## Product Change Notification / SYST-24NJAY884

ERRATA - AVR32DB28/32/48 Silicon Errata and Data Sheet Clarifications Errata Document Revision

# AVR32DB28/32/48

## Silicon Errata and Data Sheet Clarifications

Figure 34-1. DAC Block Diagram

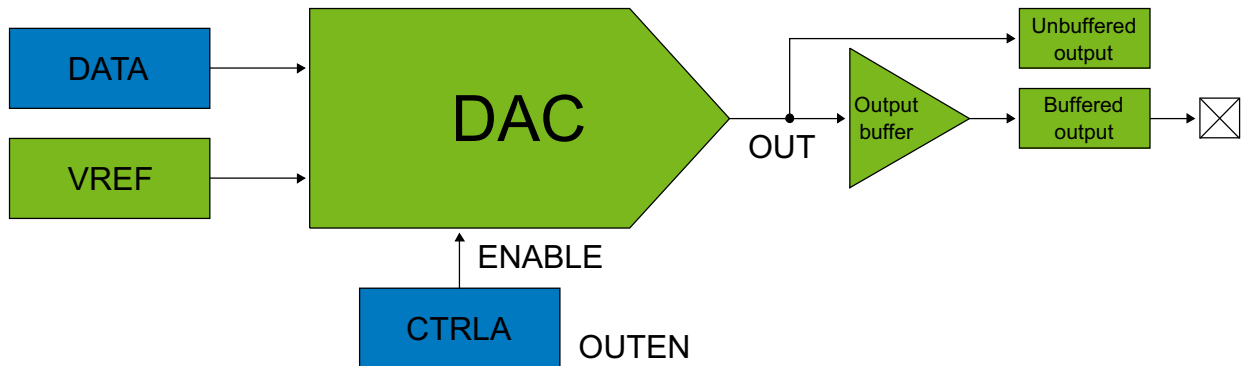
Clarifications of the block diagram and the DAC Output sub-section of the DAC peripheral has been made:

1. The block diagram is updated with clarifications to the output signal routing (buffered/unbuffered) and will replace the original block diagram.
2. Sections 34.3.2.3 (DAC as Source For Internal Peripherals) and 34.3.2.4 (DAC Output on Pin) are replaced by section 34.3.2.3 DAC Output.
